ADDENDUM NO. 2

DPW Project #2023256

April 30, 2024

**DPW/UI – Ag Science Building HVAC Phase Two
University of Idaho
Moscow, Idaho**

SHEET M5.01

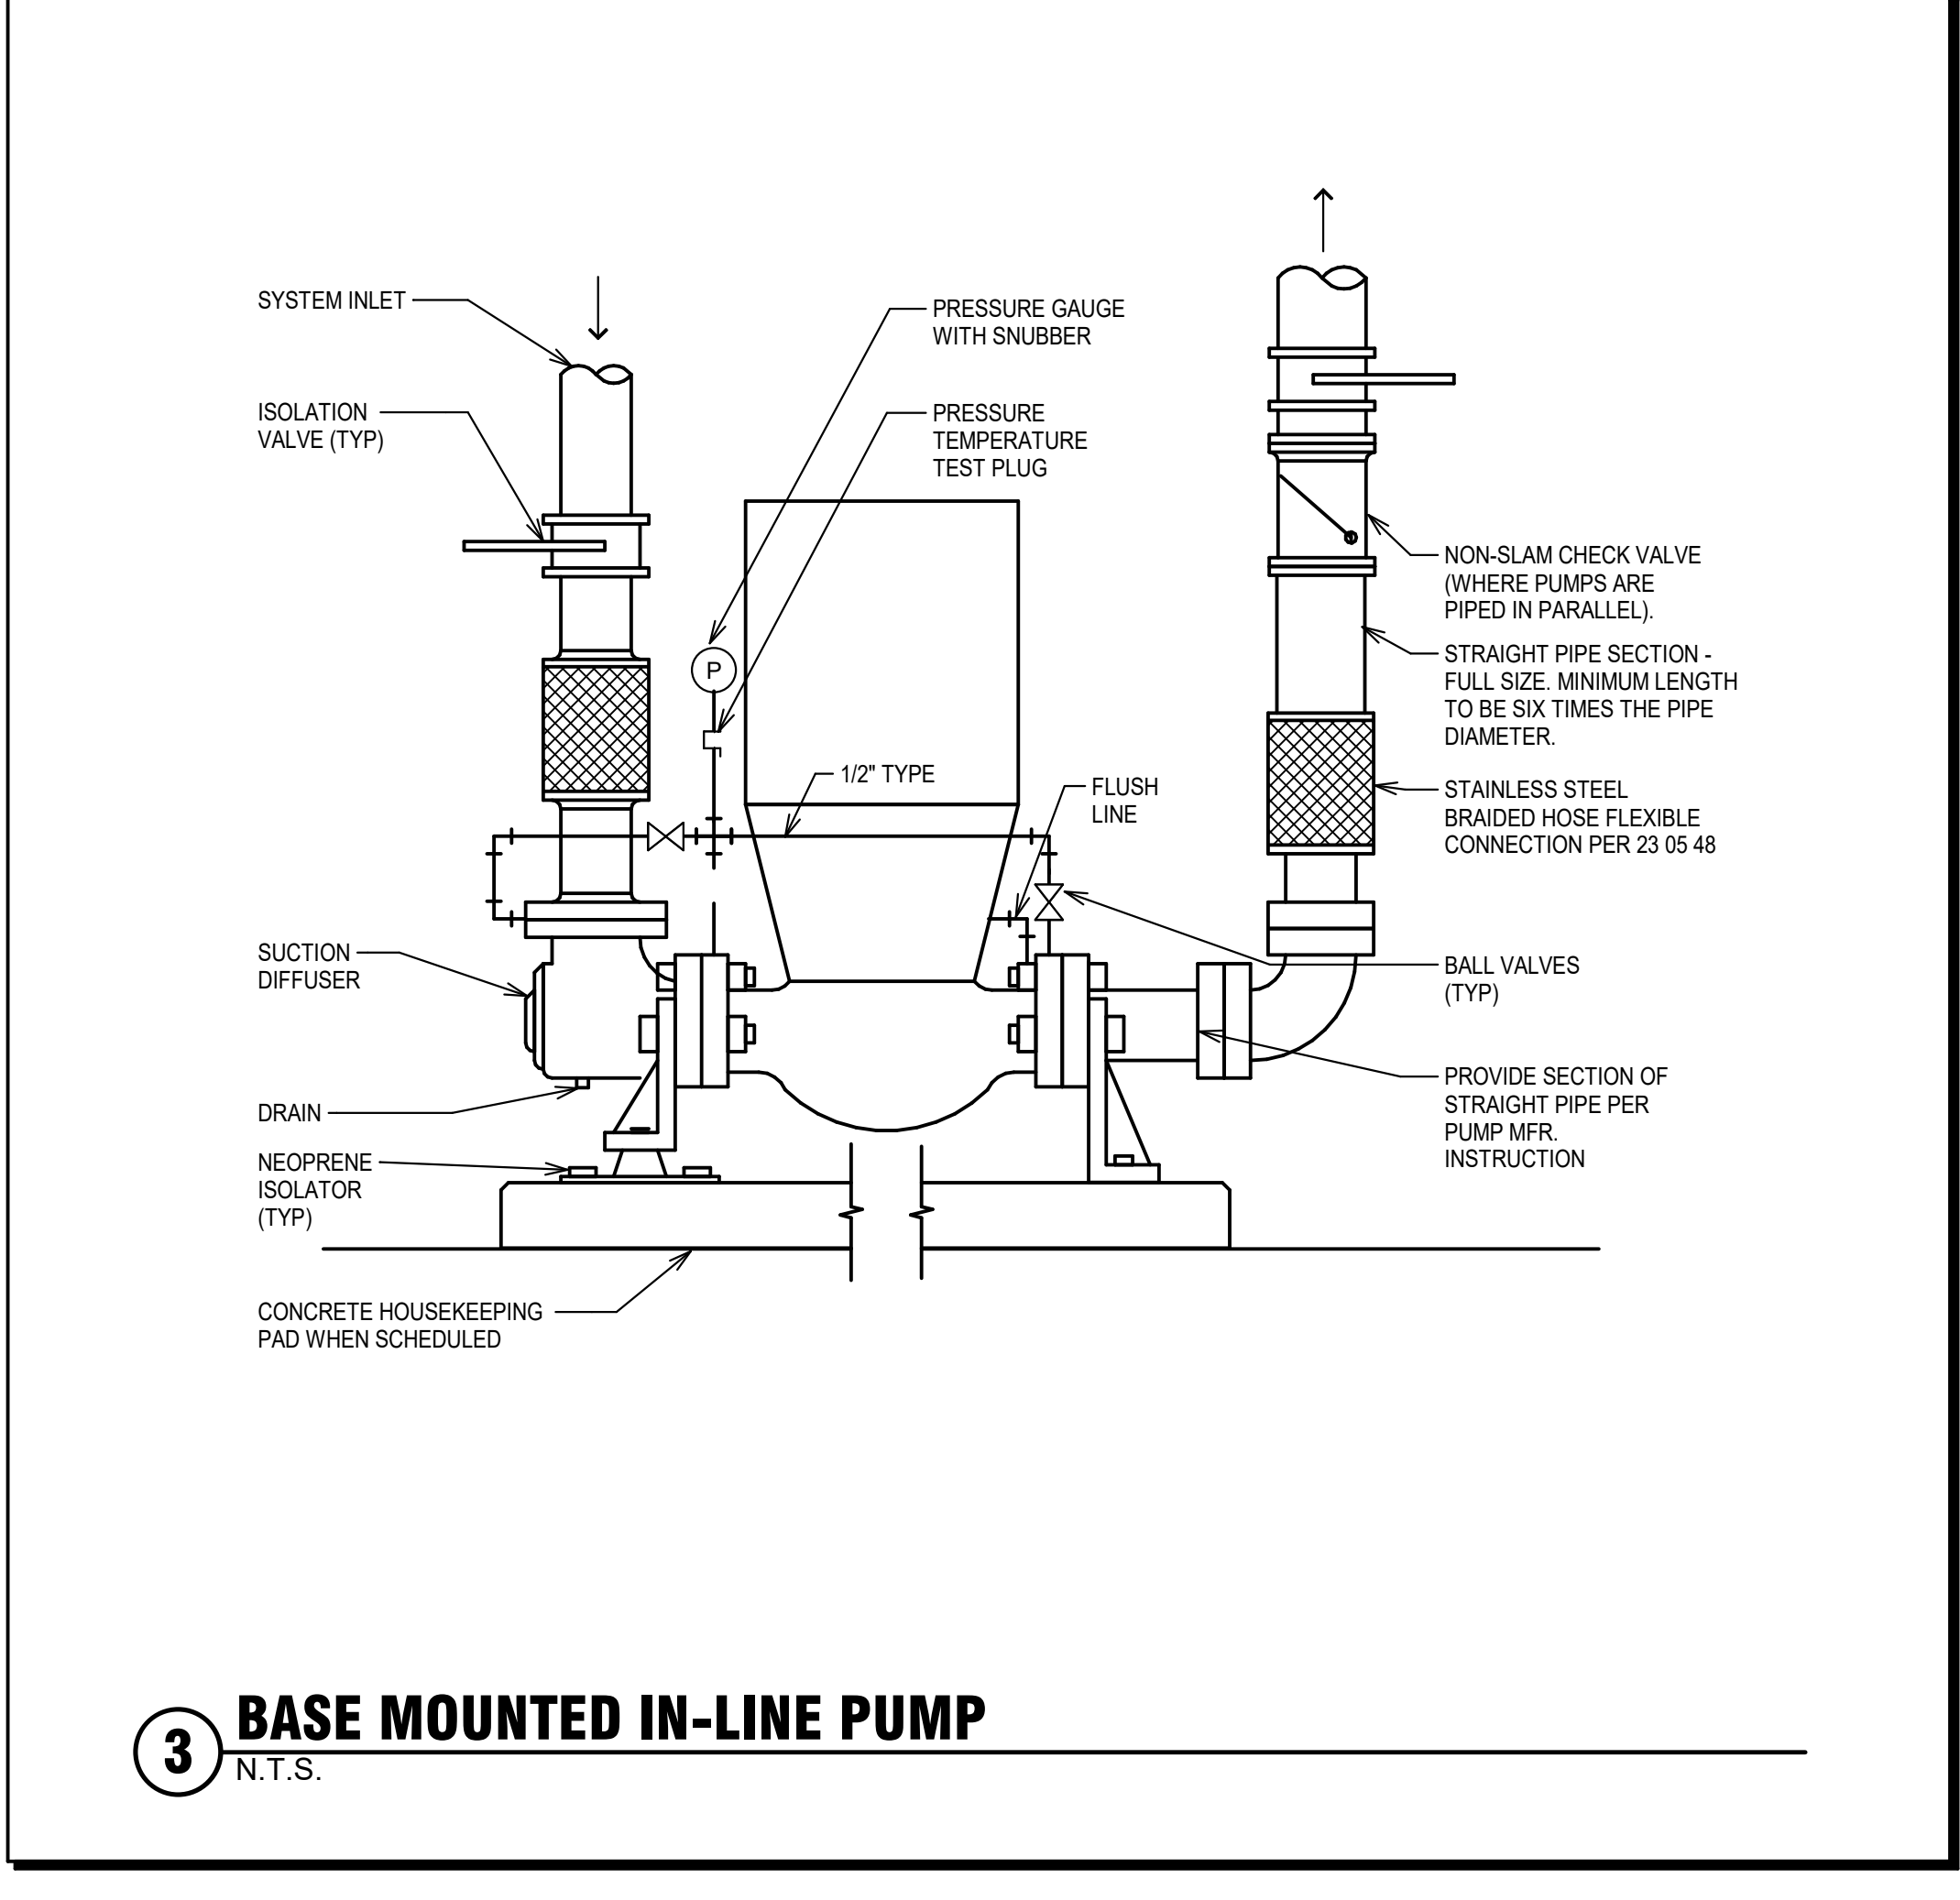
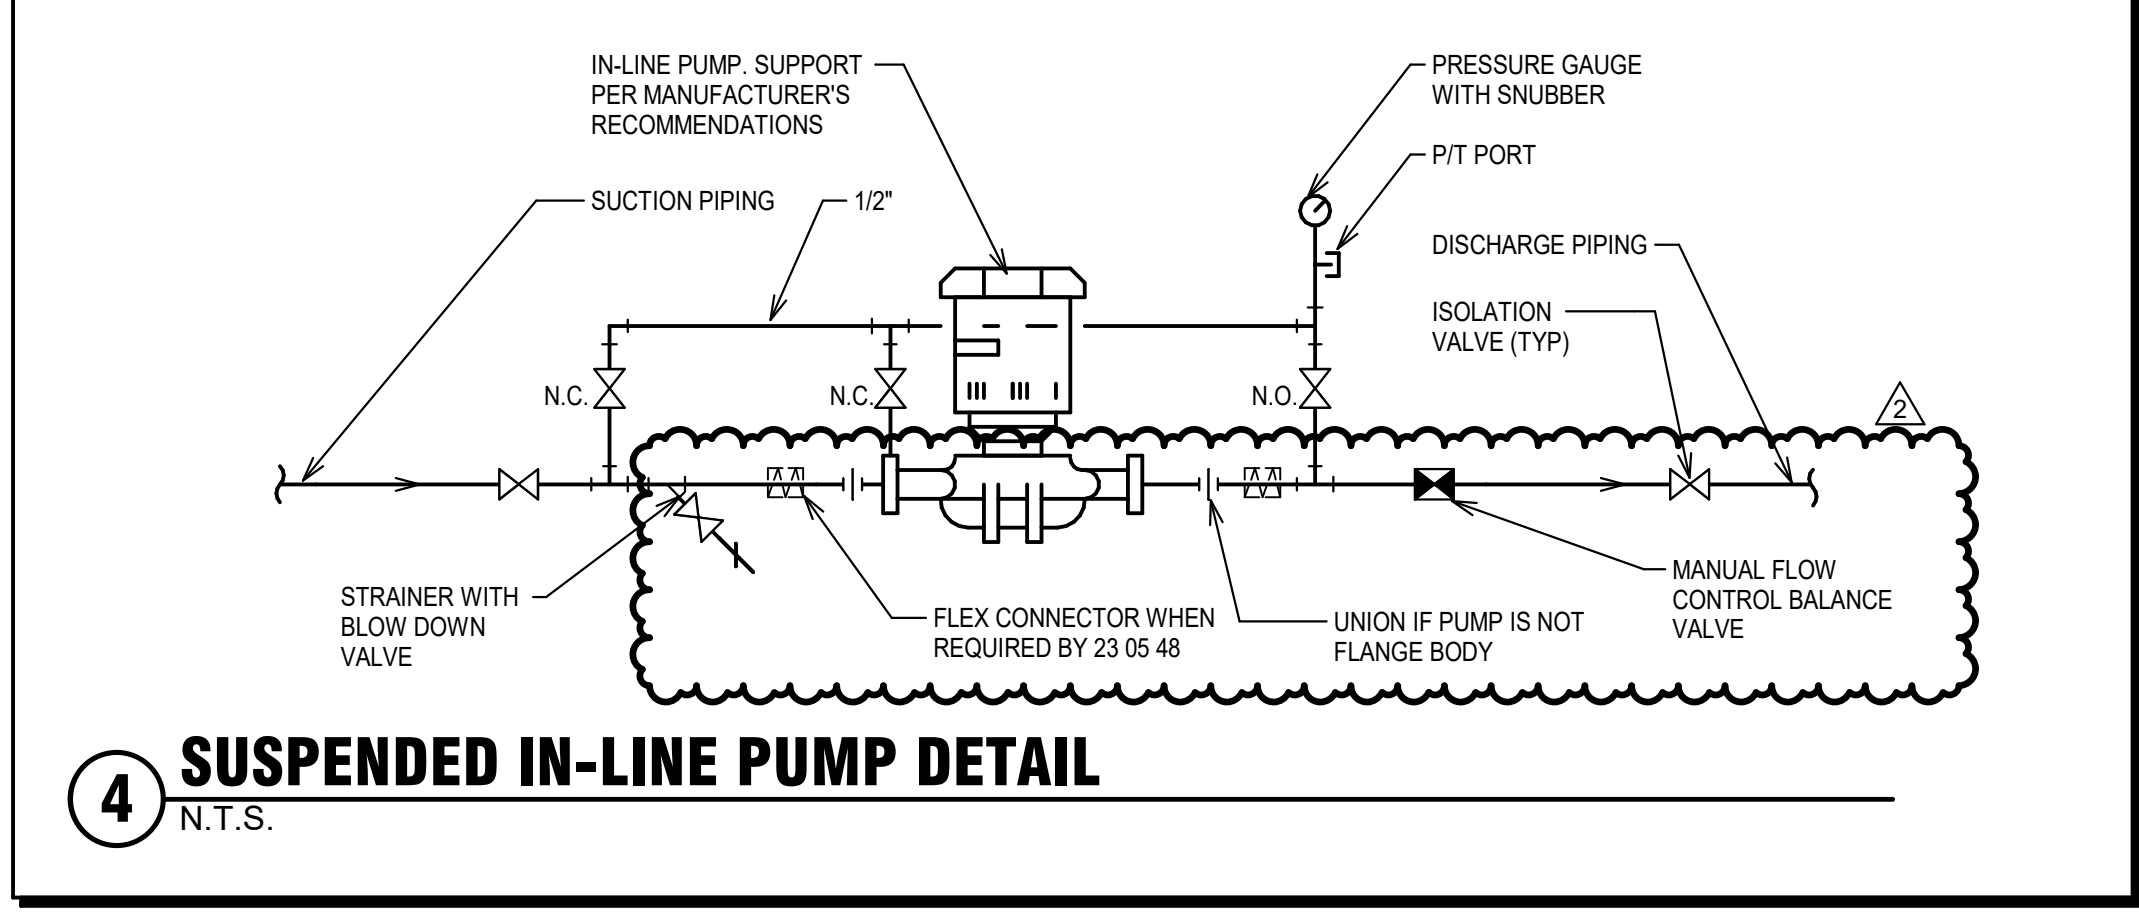
- 2.45 M4.04 - SECTIONS - MECHANICAL**
REVISION: See attached drawing with revised housekeeping pad note to indicate 6” tall housekeeping pad.
- 2.46 M5.01 - DETAILS – MECHANICAL**
REVISION: Revised detail to indicate unions on detail #4. See attached drawing.

REVISION: Revised detail to indicate unions and clarify drain valve location on detail #5. See attached drawing.

ADDITION: Added flexible pipe connectors on detail #3. See attached drawing.

DELETED: Deleted reference to maximum mounting height for drain valve in detail #7. See attached drawing.
- 2.47 M5.03 - DETAILS – MECHANICAL**
ADDITION: Added flexible pipe connectors and manual balancing valve on detail #4. See attached drawing.
